**Concept Plan at Shepherds Bay Foreshore,  
Meadowbank and Ryde**

***MP09\_0216 MOD2***

Environmental Assessment Report  
Section 75W of the *Environmental Planning and  
Assessment Act 1979*

November 2016

**Figure 8: Comparison of the approved (left) and proposed modified (right) Stage A building envelope (Source: proponent's application)**

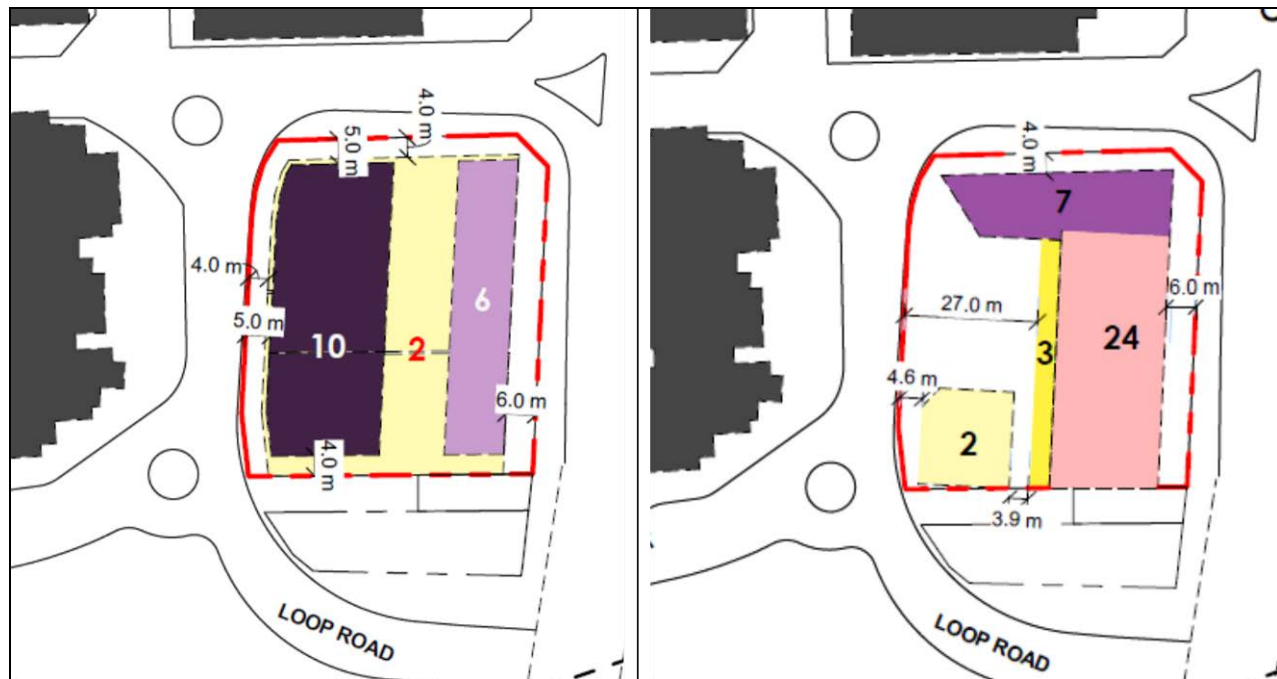
The current proposal seeks to amend Stage A building envelopes as follows (**Figure 8**):

- increase the height of the tower component of Stage A from a maximum of 10 storeys (RL 57.70) to 24 storeys (RL 95.80);
- modify the layout of the building envelope locating the tower component on Church Street and including an open space to the rear; and
- increase the height of lower-scale building envelope from six to seven storeys.

The Department does not accept the proposed 24-storey height is appropriate given this height will result in a completely estranged scale and height relationship with nearby and adjoining development. In particular, the Department notes the proposed height would be approximately six times the height of any development allowed (under the Ryde LEP 2014) along Church Street, over three times the height of the up to seven storey buildings to the north and west, and over two times the height of the highest components of the remainder of the Concept Plan site. In this context the proposed development is fundamentally contrary to Planning Principle no.1 as it would appear particularly incongruous, isolated, and would visually dominate the skyline at local, distant and river views.

The Department therefore recommends a modification requiring the Stage A building envelope be reduced by nine storeys in height (from 24 to 15 storeys). The Department notes the competition winning scheme included beneficial urban design outcomes, including a public plaza and reconfigured building envelope layouts when compared to the original Concept Plan. Therefore, to ensure these benefits are not discouraged, design excellence is not stifled and the best overall outcome can be achieved, the Department recommends a maximum 15-storey height limit and provide the proponent with the opportunity to recast the scheme to achieve this height.

**Figure 15: Approved (left) and proposed (right) view north-west from Waterview Street (Source: proponent's application)**

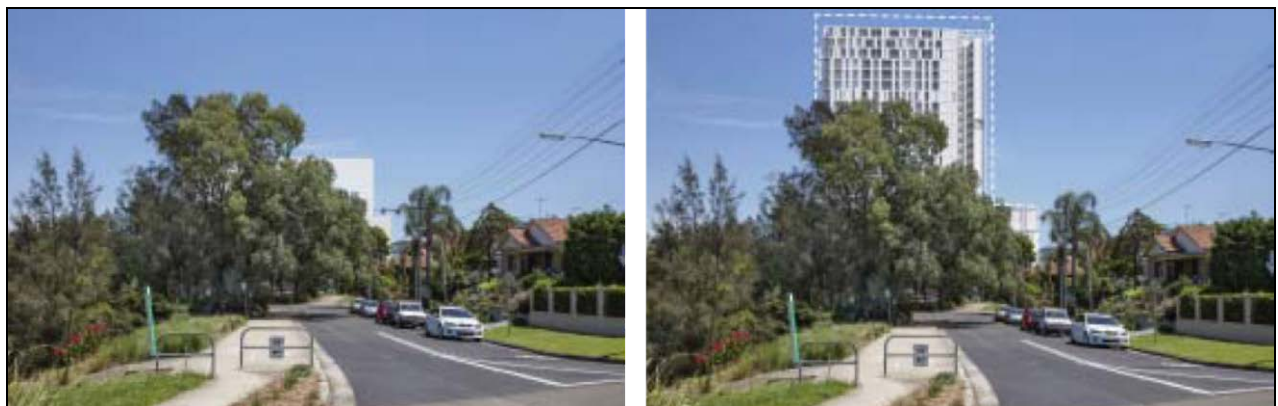
The above visual analysis indicates, regardless from what direction the proposed 24-storey building envelope is viewed from, it would appear significantly taller, bulkier and more visually dominant when compared to the approved 10-storey building envelope. In addition, there are substantially less views in which the tower would be seen solely in its comparatively slimmer side-profile.

**Figure 16: Building envelope massing, indicating 10-, 15- and 24-storey heights (Base source: proponent's application)**

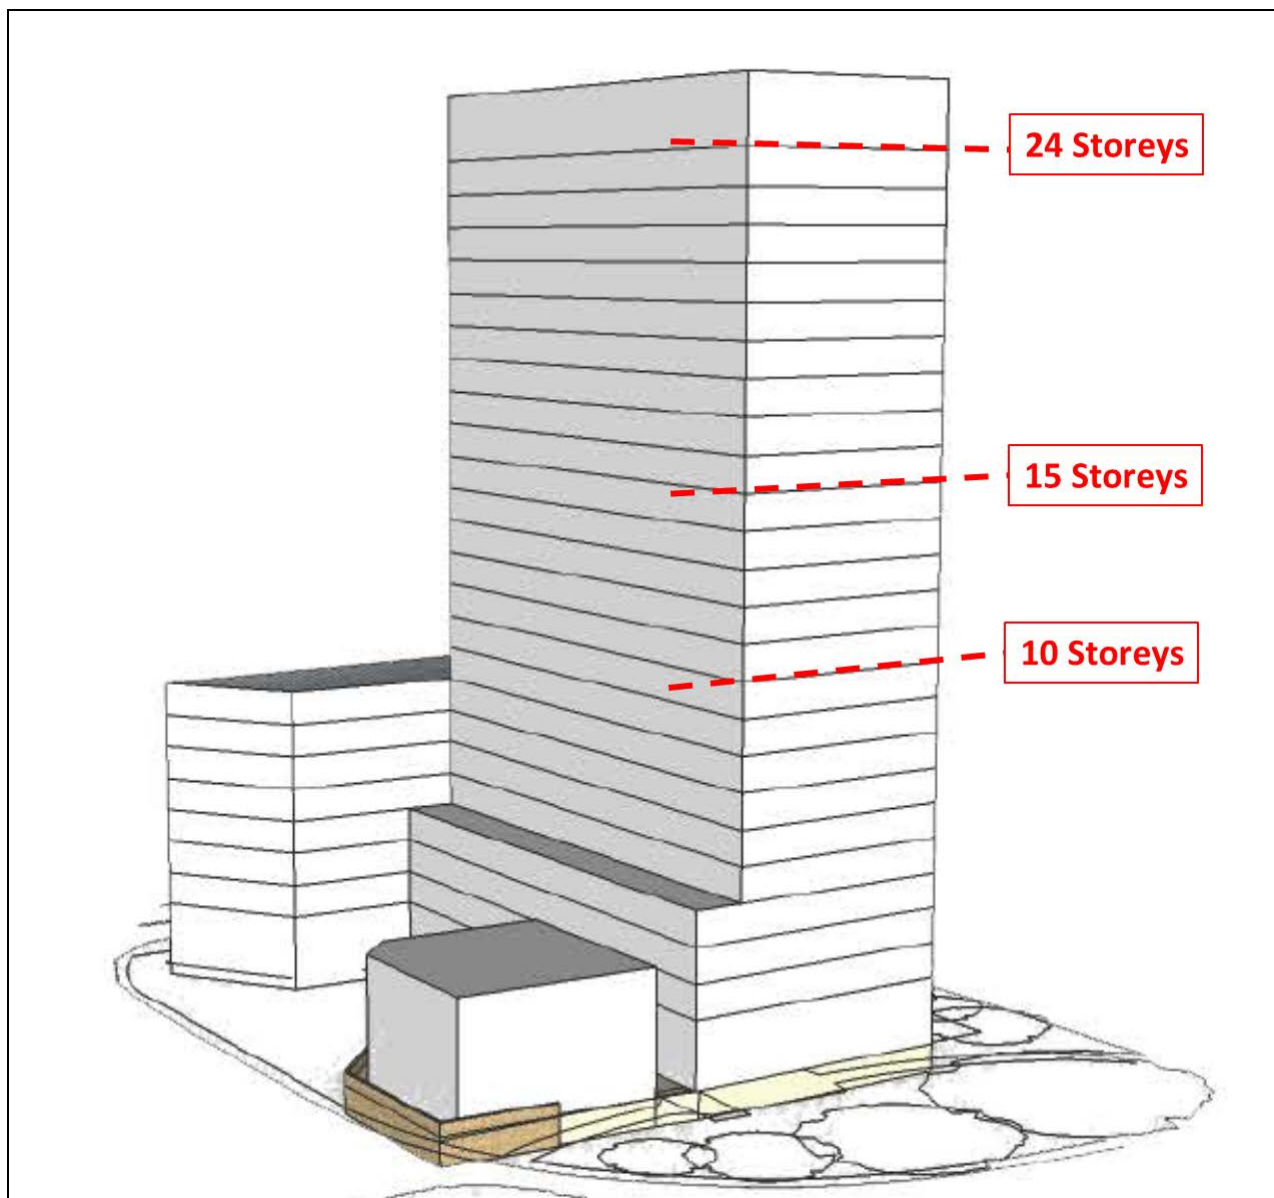
The Department considers the proposed increase in height fails to address Planning Principle no.1 as set out in the LEC Case. The Department notes in particular (refer to **Figure 16**):

Having regard to the above, the Department maintains its original view that a 15-storey height should reasonably apply to the site, as a maximum. Whilst this height remains significantly taller than the nearby up to seven storey buildings, it retains a scale relationship with the wider Shepherds Bay Concept Plan and will allow the site to substantially fulfil its gateway properties without resulting in the significant adverse impacts as discussed above.

The Department considers a 15-storey height addresses Planning Principle no.1 as it would facilitate the provision of a building that provides a marker for the site while having an appropriate relationship to the immediate surrounding area. Such a height is also considered consistent with what may be reasonably expected under the Concept Approval height controls.

**Figure 17: Indicative overshadowing impacts of the Stage A building, with overshadowing from the approved building in red, design excellence building in orange and proposed building in yellow (Source: proponents response to exhibition of the PPR)**

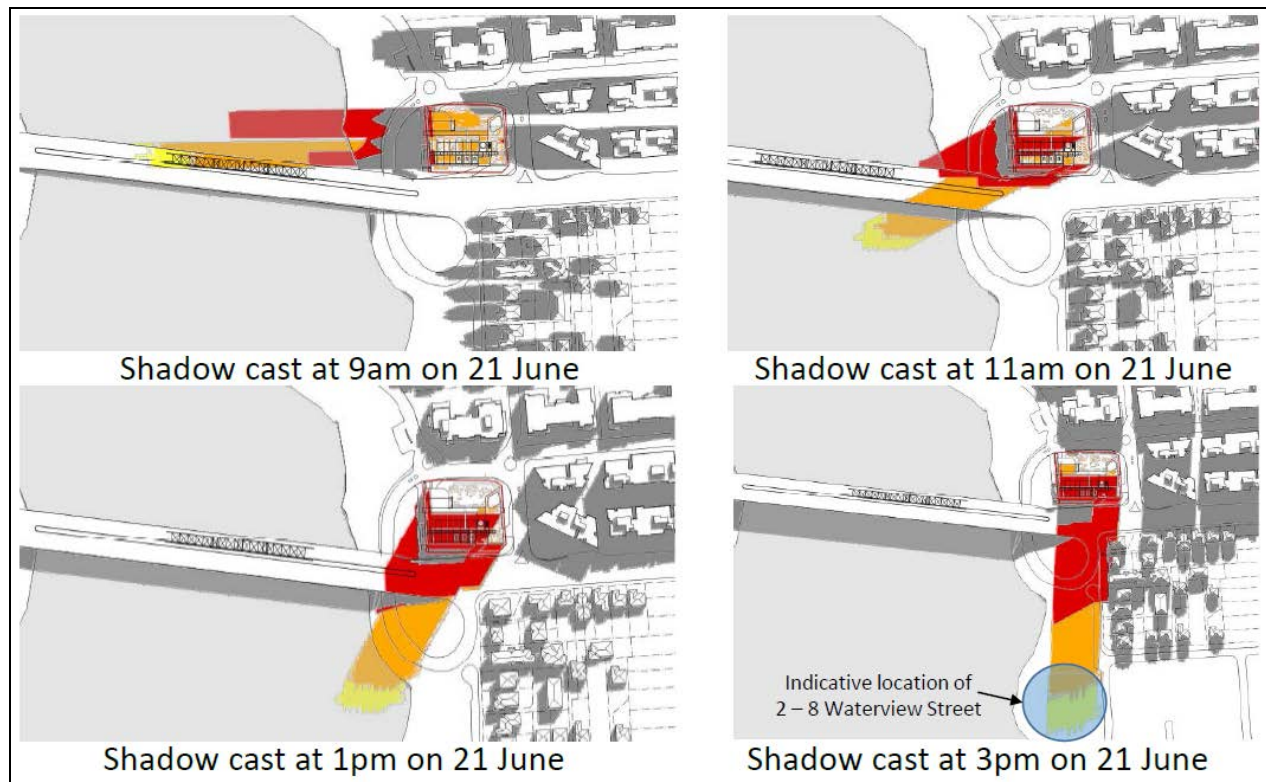
The Department notes that Council and public submissions have raised concerns about potential overshadowing impacts of the Stage A building envelope on properties on Waterview Street.

The proponent has provided an analysis of potential overshadowing impacts of the proposed Stage A building envelope on the surrounding area in mid-winter, being the worst case scenario. This compares the indicative overshadowing impacts of the approved 10 storey building (shown in red), the 19 storey design excellence building (shown in orange) and the proposed 24 storey building (shown in red) (**Figure 17**).

The Department has carefully considered concerns raised in submissions and the proponent's shadow analysis, and is satisfied that any overshadowing impacts as a result of the proposal on surrounding properties are reasonable for the following reasons:

**Figure 18: Approved (left) and proposed (right) Stage 2 and 3 building envelope storey height plan (Base source: proponent's application)**

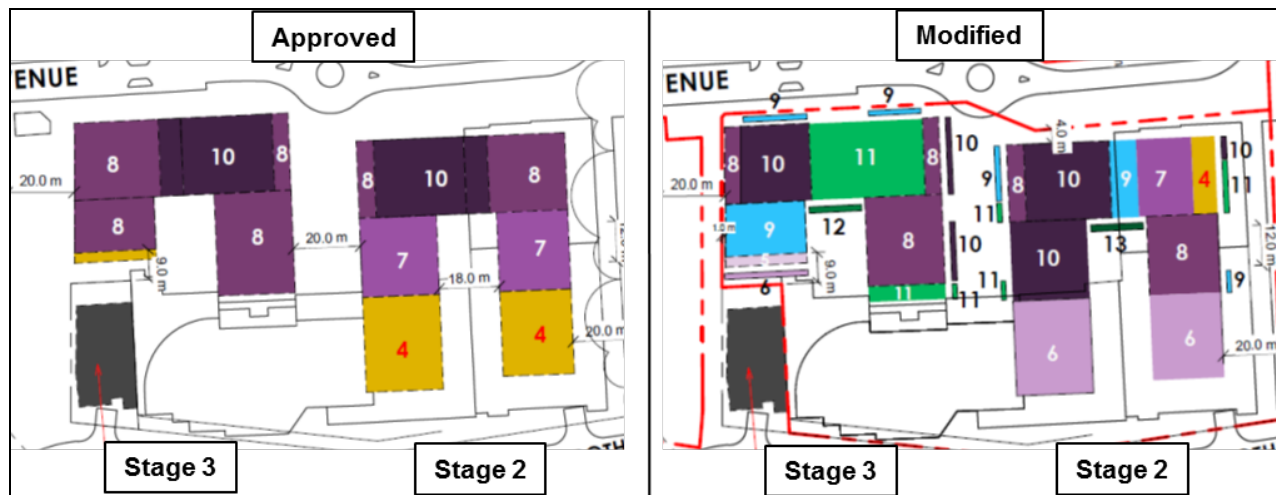
The modification seeks approval for varied increases in the number of storeys contained within the approved building envelopes of Stages 2 and 3 (i.e. no increase in overall building envelope height) and deletion of FEAR 3A. A comparison between the approved and proposed storey height plan is provided at **Figure 18**.

The proponent states that storey heights have been amended in response to the confirmation of precise storey heights in relation to steeply sloping land, rationalisation of void spaces, re-grading of internal courtyard levels and the removal of the community centre from Stage 3 and asserts the additional storeys are acceptable and FEAR 3A can be deleted, as:

The Department agrees, as the revised storey height plan takes account of elevations at steeply sloping locations, the exception within FEAR 3A allowing for an additional storey is no longer necessary and can be deleted. However, the Department considers it important that future developments continue to be required to comply with the approved storey height plan and therefore this part of the FEAR is retained.

Figure 19: Approved (left) and proposed (right) Stage 2 building envelope height (Source: proponent's application)

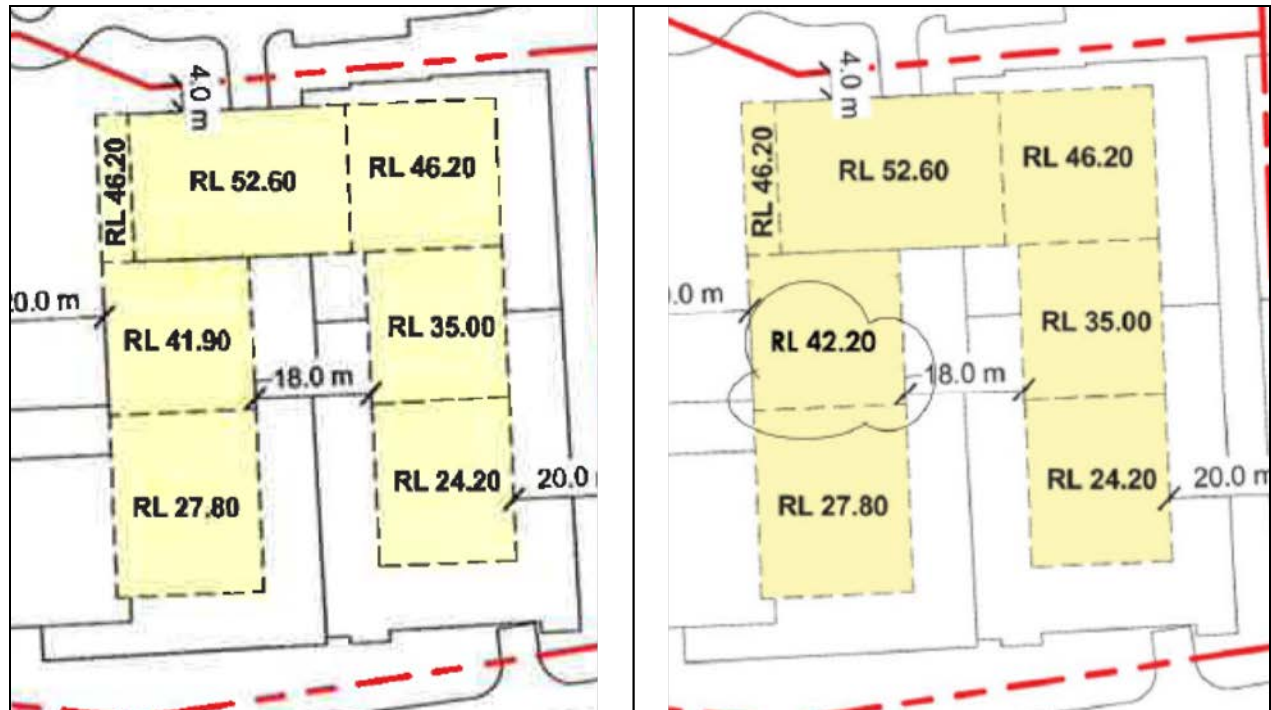
The modification proposes a localised increase the height of part of the western arm of Stage 2 by 300mm (from RL 41.90 to RL 42.20) as shown at **Figure 19**.

The proponent has stated this increase is to facilitate the provision of appropriate floor to ceiling heights in this part of the building.
